Issue Date: July. 15th, 2021

Notification Subject: IC Vendor informed PCN driver IC SC7283-G4

- **Effected model:** RFE430W Series

Parts No.	Before Change: ICSC7283321XXXXXXX00	After Change: ICSC7283321XXXXXXX01
FPC Appearance (FPC has been modified with the circuit according to the supplier's recommendations)		
Module Appearance (Performance remained the same)

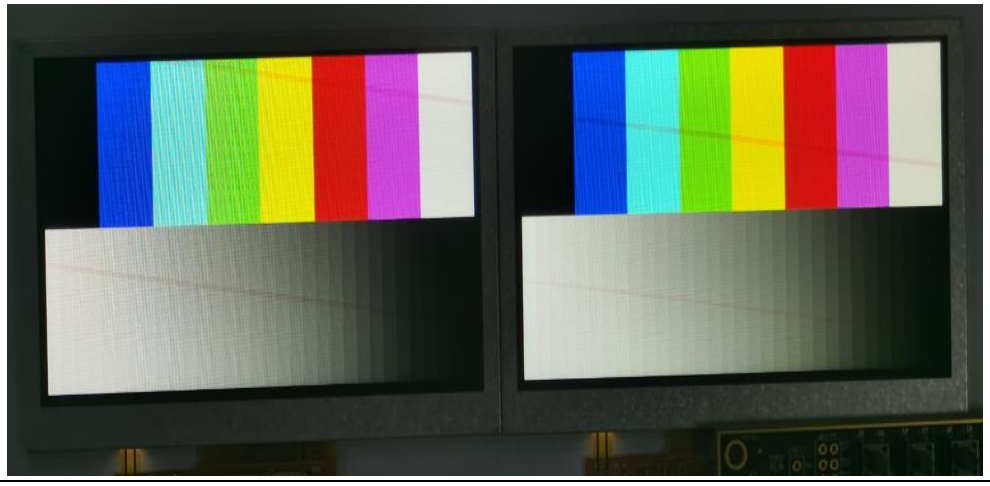
- **Description:** The IC vendor informed changing Wafer Plant due to original IC Wafer Plant's capacity is fully occupied. We also modified the VDDI range and added a set of capacitors from VCC to ground to enhance the ESD ability.
